Thank you for your letter associated to our manuscript submitted to ACP. We attached our point-to-point responses to the latest referee report to the submission. Here you can find our responses to your concerns described in your letter. References added here can be found below this response.

Thank you for the review of our revised manuscript. Please find below our responses to your comments.

*Figure 1: MLS and MIPAS HNO<sub>3</sub> VMRs vs. N<sub>2</sub>O VMRs at high latitudes for both hemispheres during the local fall months in 2011. Data screening as recommended by the MLS documentation has been applied to the MLS data. The pressure range 60 to 75 hPa is shown.*

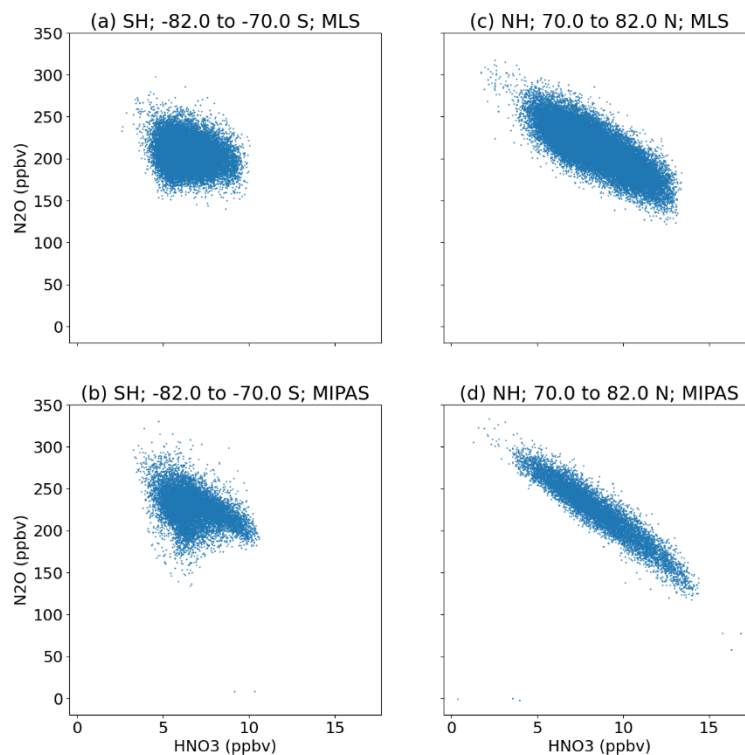
*1. For me also the answer why you cannot compare WACCM to MLS is not satisfying. I compared ECHAM5/MESSy simulations to both instruments without encountering any problems (Khosrawi et al. 2017, 2018). Both instruments are suited for comparisons with model data. Generally, I would say that the decision is rather made by which data set is available and maybe also to some extent which fits better to the model data. The comparisons in Khosrawi et al. (2018) showed that e.g. the HNO<sub>3</sub> distribution looks generally the same, but the absolute values are quite different, which I think will in case of your study change the results to some extent.*

*4. Since there are large differences between the instruments I doubt that you can find a general solution for the "best" NAT density value by just comparing with one instrument. There we are again back at comment 1, I am not convinced by your arguments that it is technically not possible to perform the same study with MLS data. You need better arguments why you only use one instrument and why only MIPAS.*

It is important to note here that the comparison with MIPAS in the manuscript is based on a sampling of the model at exactly the same locations and times as the MIPAS measurements. Therefore, this is

based on single point comparisons, which means that precision of the instrument is crucial when applying our method. As stated e.g. by Piccolo and Dudhia (2007) and Sheese et al. (2016), the precision of MIPAS (about 0.2 ppbv or even lower) during the local spring months is substantially better than MLS (about 0.6 ppbv, see MLS data documentation, Livesey et al., 2022). In addition, the vertical resolution of MIPAS is about 3 km in the stratosphere which is higher than for MLS. MIPAS was able to measure profiles to latitudes up to 87 °N/S which is not possible with MLS. Figure 1 shows MLS and MIPAS HNO<sub>3</sub> vs. N<sub>2</sub>O for both hemispheres (70 to 82 °N/S) at around 68 hPa during local fall months and it can be seen that the scatter is considerably larger for MLS than for MIPAS. For all these reasons, we decided to compare our results with MIPAS. Note that MIPAS is not the only dataset used but we also use ozonesondes for comparison with the same message as the MIPAS comparisons, which supports the conclusions of our study.
